ADDENDUM TO RFP DOCUMENTS

SOLANO COMMUNITY COLLEGE	ADDENDUM #02
	Project: Solano Community College District Vacaville Center HVAC Upgrade Project Project #18-010
	Date: February 28, 2018

Addendum # 02 – The following clarifications are provided based on questions received and must be added/considered when completing your submittal: Acknowledgement of receipt of this **ADDENDUM** is required in the proposal’s cover letter of introduction. Please clearly note the addendum date and number.

1 DUCT PENETRATION
3" = 1'-0"

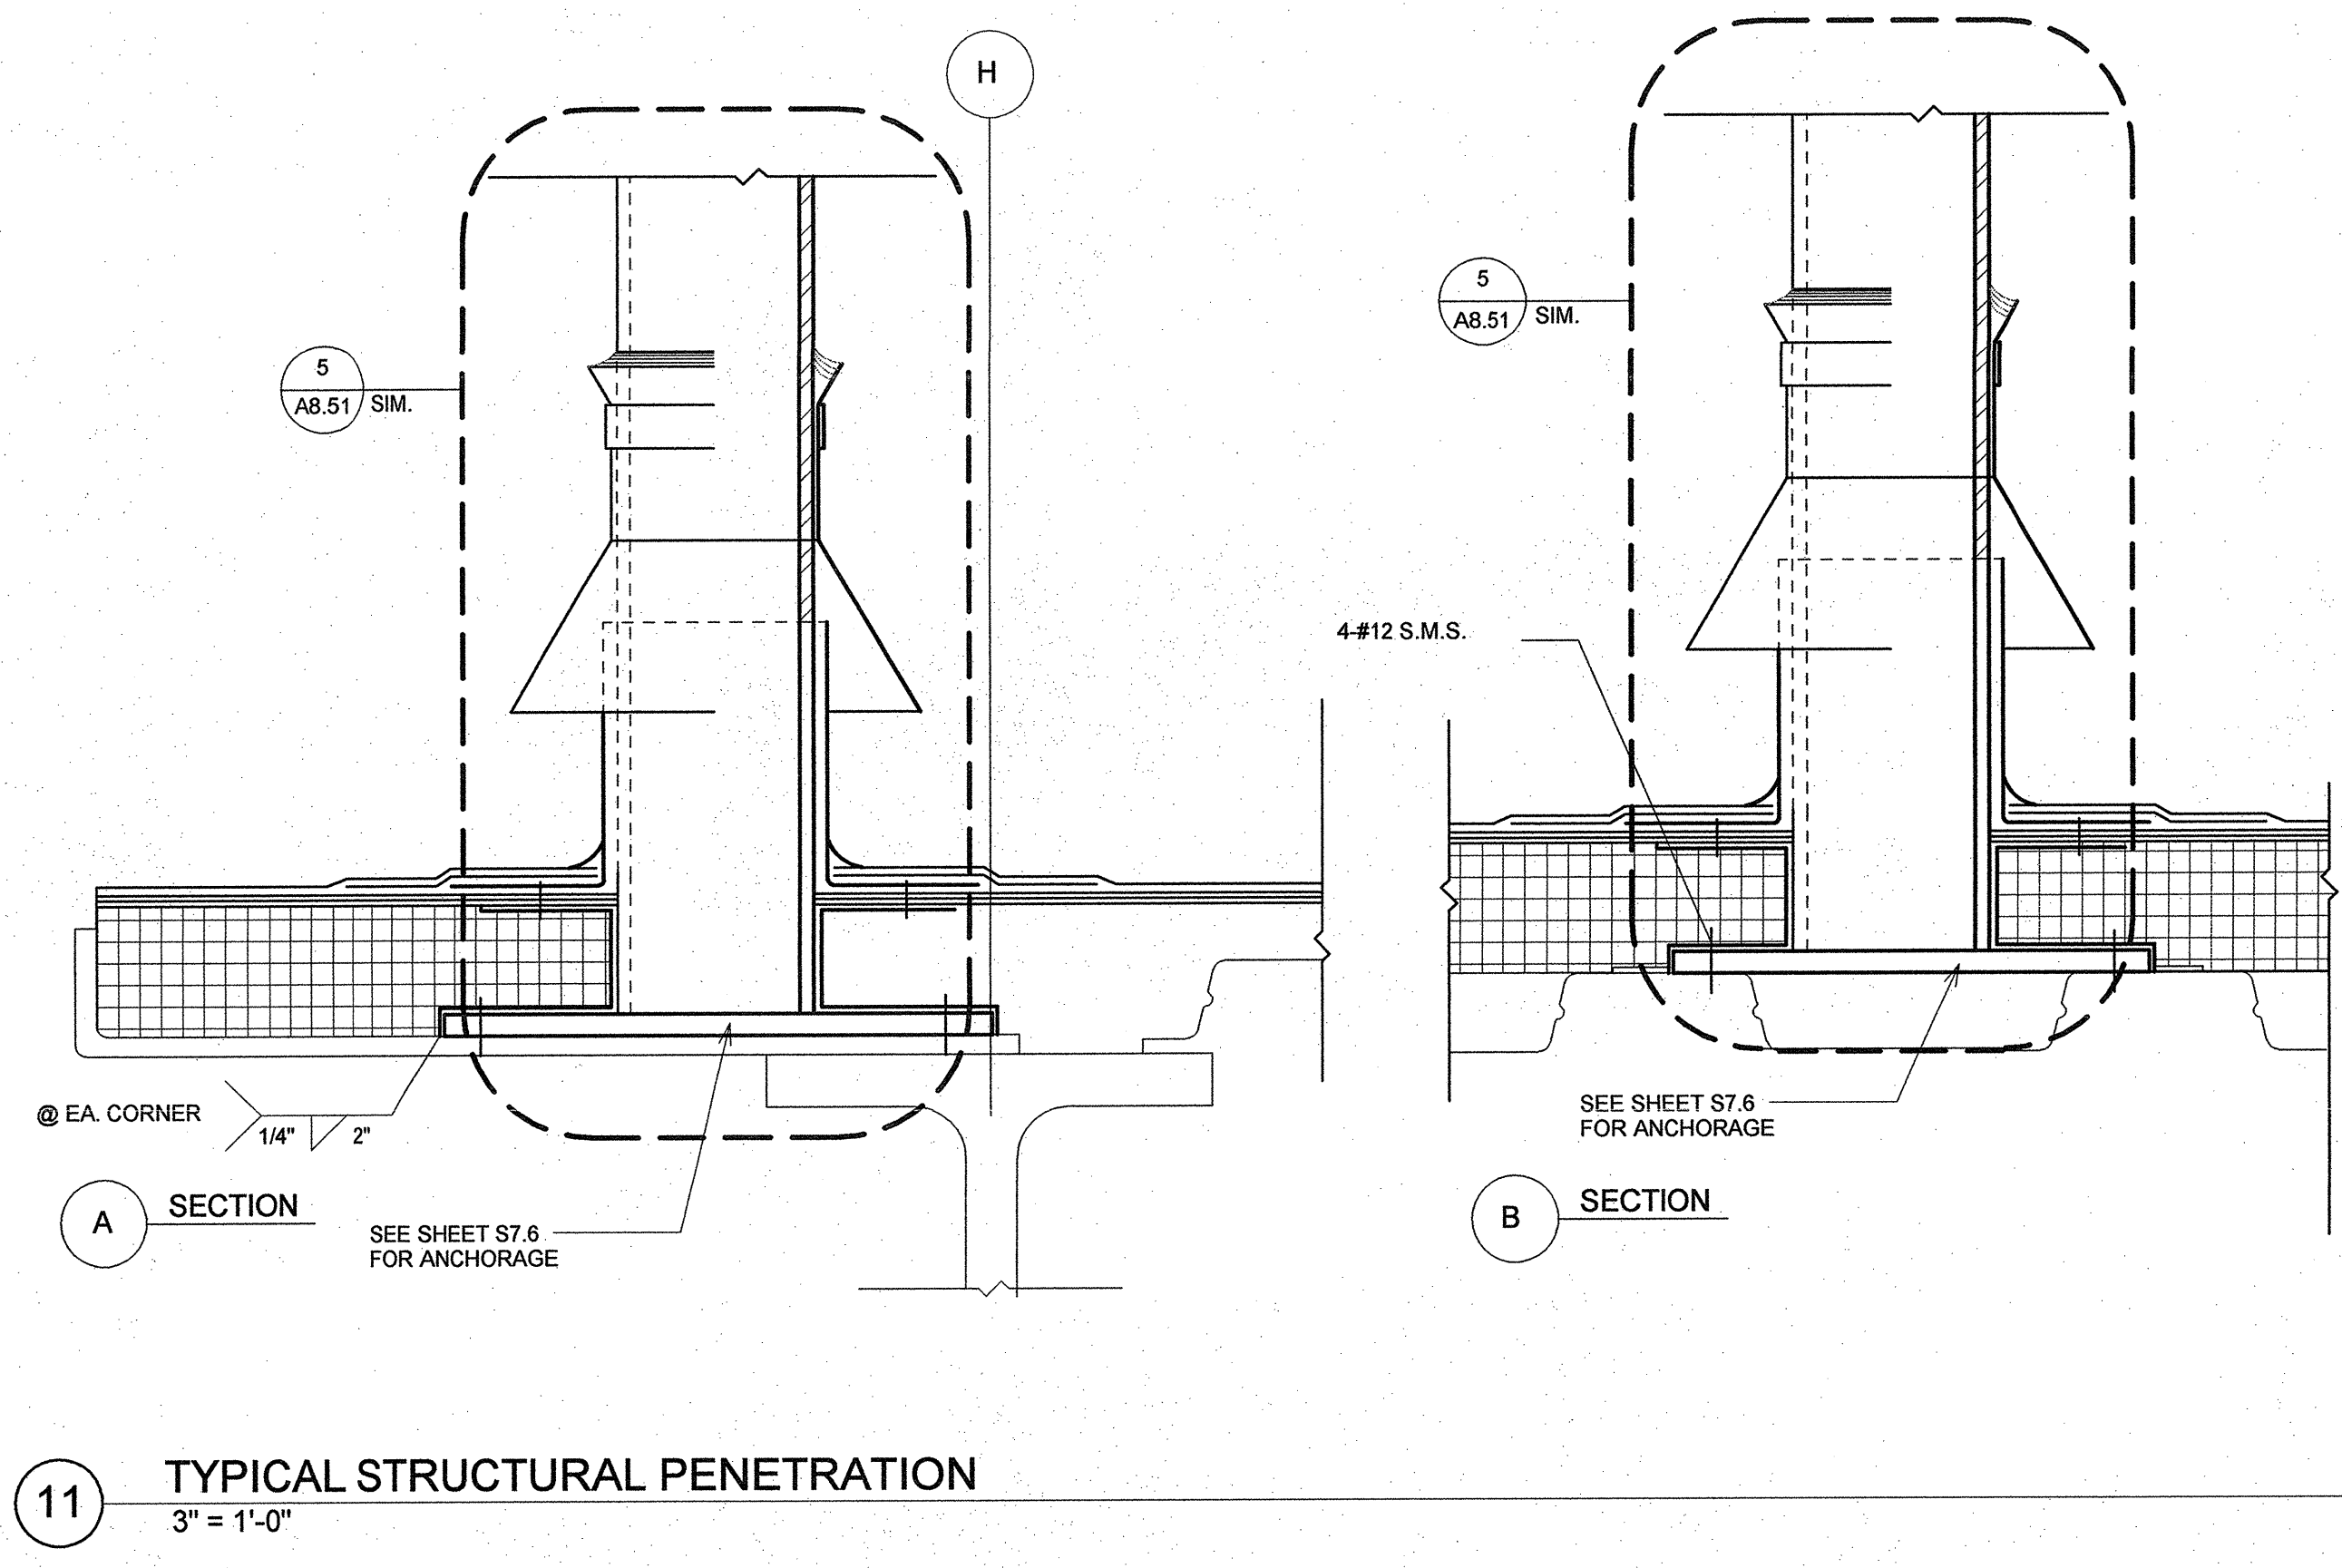
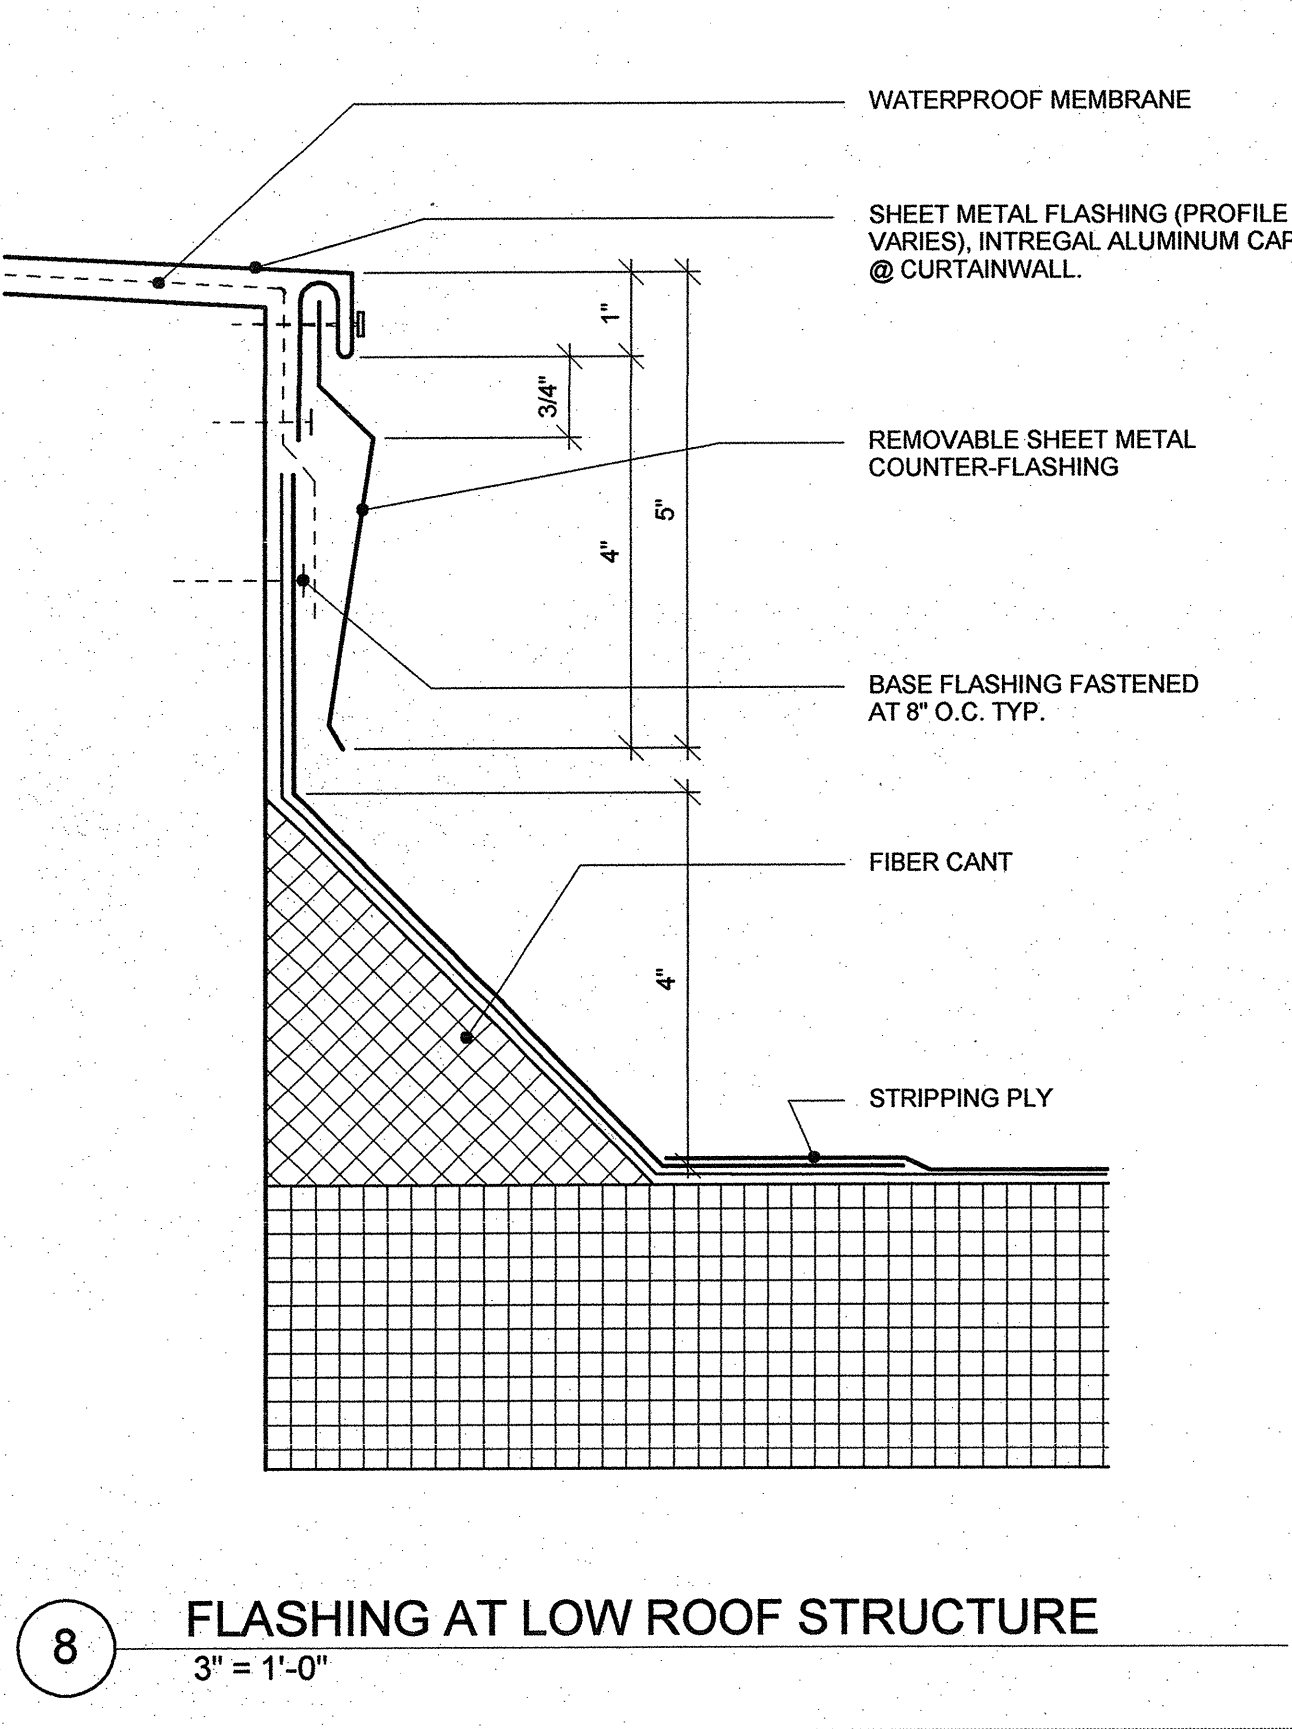
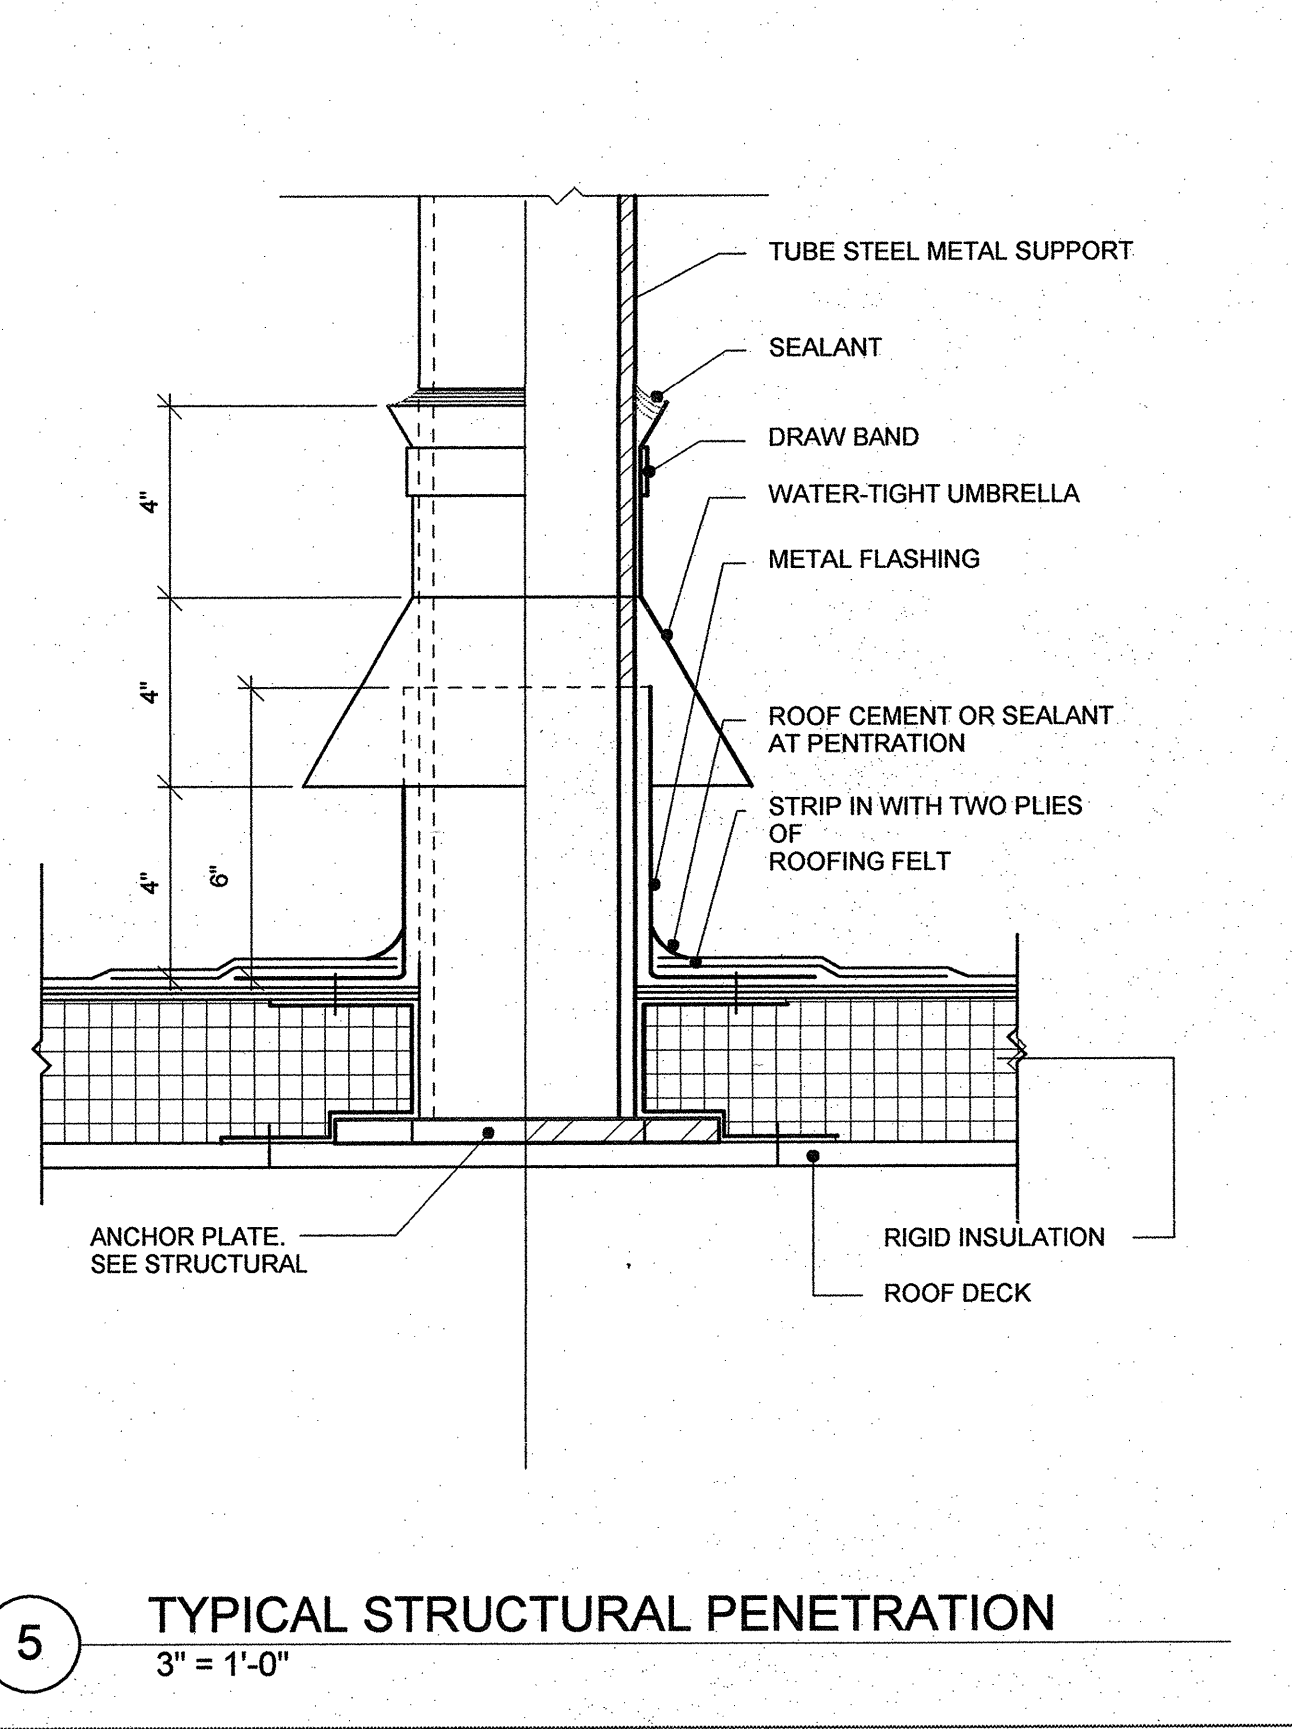
QUESTION –During the job walk it was determined that the existing roof system is fully tapered by rigid insulation ½” in 12” slope with a minimum of 6” at drains but not shown on the drawings. Please confirm and provide new details identifying existing insulation.

ANSWER – Please see the attached As-built drawings: A8.51, A8.52 & A8.53 for all the info of the existing roof condition (see attached).
